CORRECTIVE ACTION REPSONSE

DOCUMENT NUMBER: 713400261
FACILITY NAME: SKINNER RIDGE 36-BV
Location: CHEVRON USA INC SKR-65S98W/36NWSW
Location ID: 336048

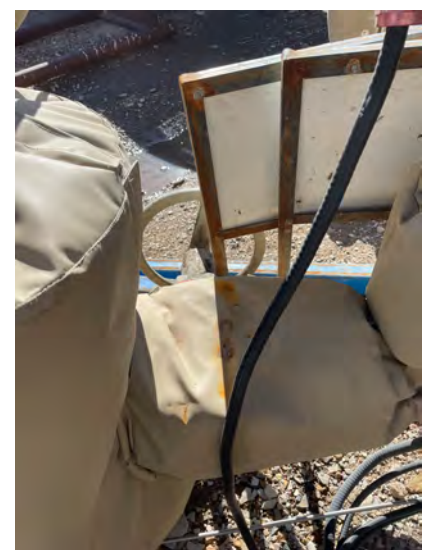
CORRECTIVE ACTION #2 COMMENT: Chemical tank has no labeling.

CORRECTIVE ACTION RESPONSE: Labels have been added to tank - 09/09/2024

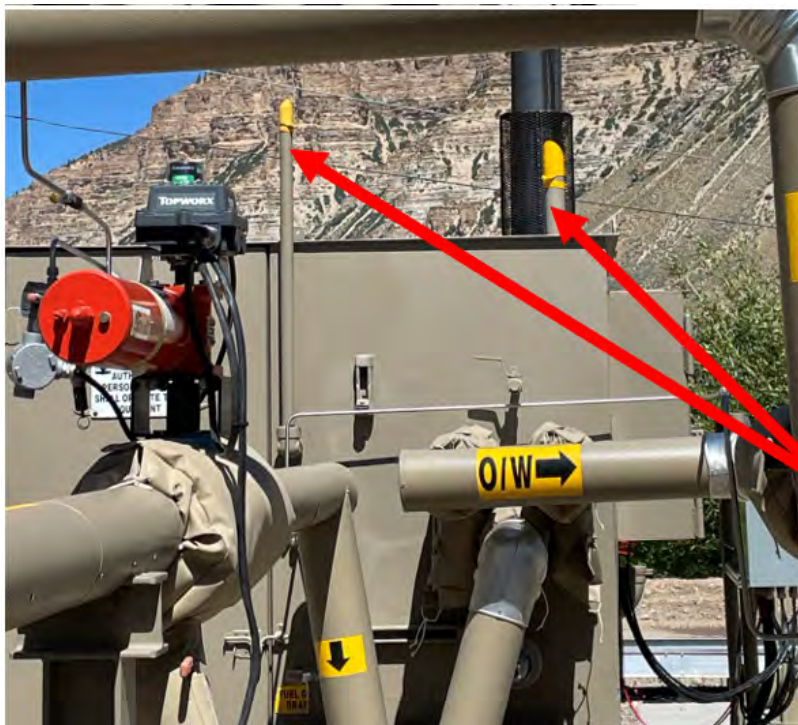
Multiple open ended piping/wildlife hazard/ available for entry by wildlife.

Piping was unhooked to allow P&A rig to move to next well in operation and then reconnected - 08/29/2024.
